FINAL REPORT  
ON  
PHASE II  
CONTRACT DA 30-070-CML-1250  
A PRODUCTION ENGINEERING STUDY  
OF THE  
PROTECTIVE, CIVILIAN, CD V-805 MASK

BY  
THE GENERAL TIRE & RUBBER COMPANY  
INDUSTRIAL PRODUCTS DIVISION  
WABASH, INDIANA

24 JULY 1963

FIGURE 1. FACEMASK CUSHION CHANGES IN CHIN SEAM AREA

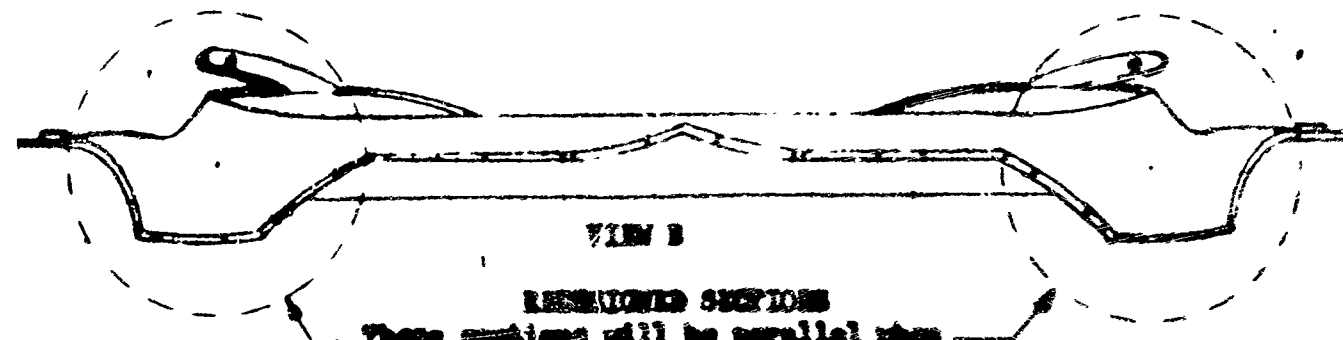
### Faceblank Design Change In Chin Seam Area

The design of the faceblank should be changed in order to reduce the scrap that occurs on the first chin seam welding operation. The weld tabs used to position the faceblank on the fixture during the first chin seam welding operation are formed at an angle during the molding operation.

These tabs must be placed in a stress while being welded to overcome the resistance caused by the angle. The heat in the stress area created during the electronic welding cycle causes the faceblank to fracture. View A, Figure 1, illustrates the present design of the faceblank in the first chin seam weld area. View B illustrates the recommended design change. The design change was too costly to institute to the molds that were produced on the engineering study. If new molds are built on future contracts, this change should be incorporated.

THESE SECTIONS SHOULD BE REDESIGNED  
AS SHOWN IN VIEW B

REDESIGNED SECTIONS  
These sections will be parallel when  
folded into the cold position

FIGURE II. CHIN STRAP WELD ON CD V-805 MASK

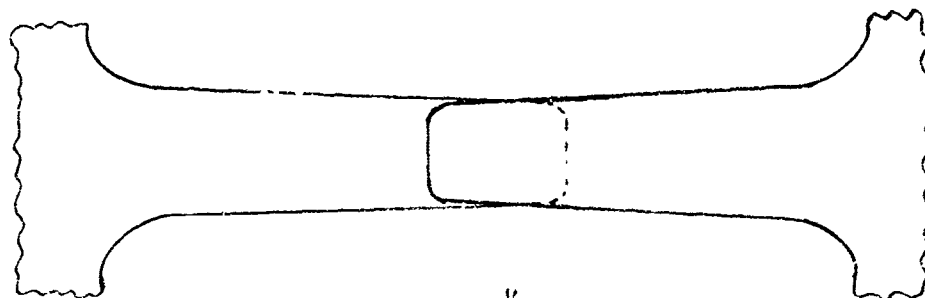
#### Faceblank Design Change In Chin Strap Area

We recommend that consideration be given to a modification in the design of these straps if new faceblank molds are produced. This operation presently uses a lap weld to secure these straps together. During Operation 100, two pieces of vinyl are layed together that are approximately 0.050" thick each with a combined overall thickness of 0.100 inches. In order to produce a smooth weld, 0.050" thickness of vinyl must be moved and blended into the rest of the strap. A much smoother weld could be performed if these straps were reduced in thickness to eliminate the necessity of trying to blend this material during the welding operation, see Figure V, page 36. It was impossible to change this area on the engineering study due to the amount of cost involved in reworking the faceblank molds.

General Tire recommends that the ends of the chin straps be reduced from 0.050" thick down to 0.025" + 0.010. The reduction in thickness would be alternated on each chin strap in order to produce matching surfaces and would extend 3/4" back from the end of the strap.

FIGURE III. FILTER UNIT EDGESEAL SECTION

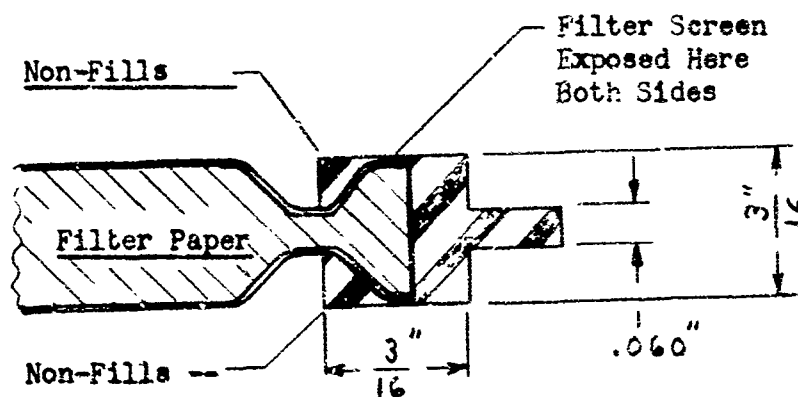
The first problem was scrap created during our production run. This scrap was mainly due to non-fills between the pinch off of the filter mold and in the edgeseal area of the cavity. Please refer to Figure III

Related to this problem also was the scrap created by the filter material and screen being exposed. The ledge created by the flange on the outside of the filter unit edgeseal has a mating surface on the faceblank. The logical solution to curing the scrap problems would be to increase the edgeseal thickness from  $3/16$  of an inch to  $1/4$  inch. A potential manufacture should be cautioned against making this edgeseal too thick because of the problems they will encounter trying to fold the mask into its normal position after the filter unit has been assembled into the masks. We would recommend that only  $1/16$  of an inch be added to the present design.

FIGURE IV.. FILTER UNIT-FACEBLANK WELD SECTION

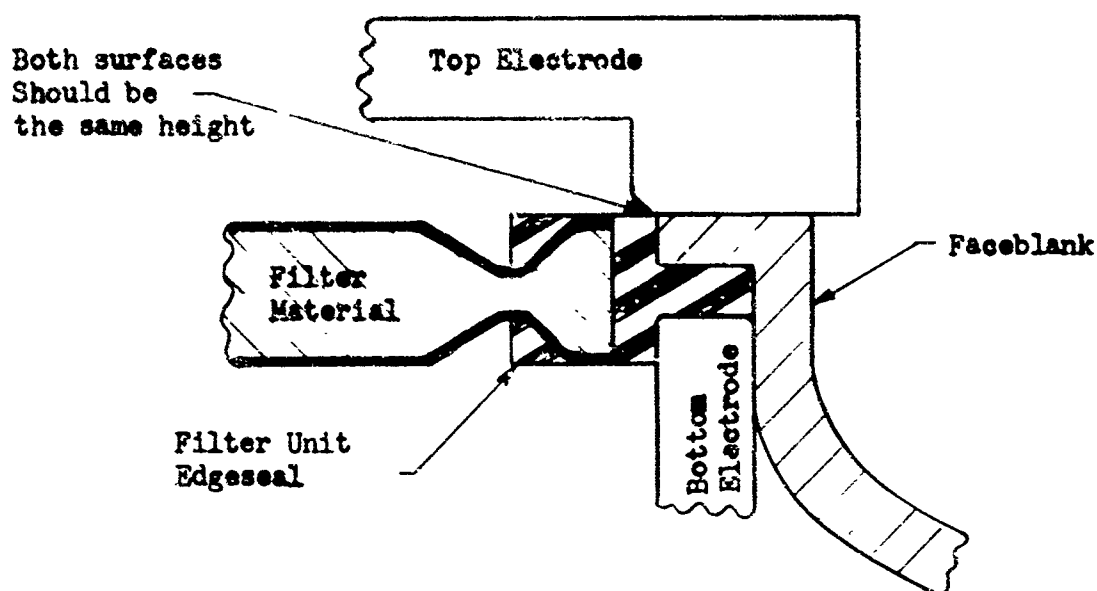
Another problem will be encountered by making the 1/16 of an inch change in the filter unit edgeseal. Consideration must be given to the mating ledge on the faceblank. If the 1/16 inch is added to the filter unit then we would recommend that a change be made to the faceblank also, refer to Figure IV.

If a change in thickness is not made in both the filter unit edgeseal and the faceblank, there will be a ledge created between the mating surfaces of the faceblank and the filter unit.

Figure V. Filter Unit Edgeseal With Offset Design

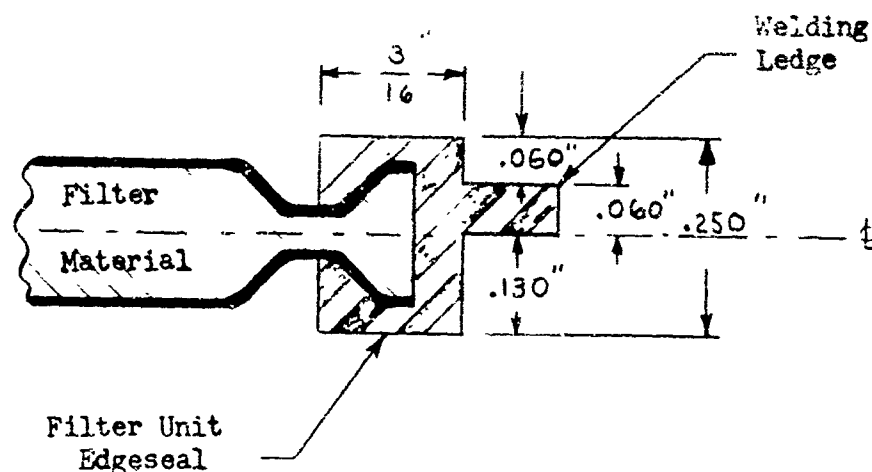
The foregoing changes are recommended only if new faceblank molds are produced along with new filter molds. If only new filter molds are going to be produced then a second alternate design could be used. The edgeseal thickness could be increased to  $1/4$  inch and the ledge remain the same thickness, 0.060 inches. The only difference would be that the welding ledge would be staggered from the center line, refer to Figure V.

An important reason exists for changing the thickness of the filter unit edgeseal. The electrical conductivity of the filter material varies greatly simply from going from the low to the high side of certain tolerances. The charcoal contained in the filter paper is an excellent conductor of electrical current. If the filter edgeseal thickness is increased, the greater the insulation will be between the electrodes and the filter paper during Operation 100, the faceblank-lens-filter unit weld; therefore lowering the chances of a short circuit.
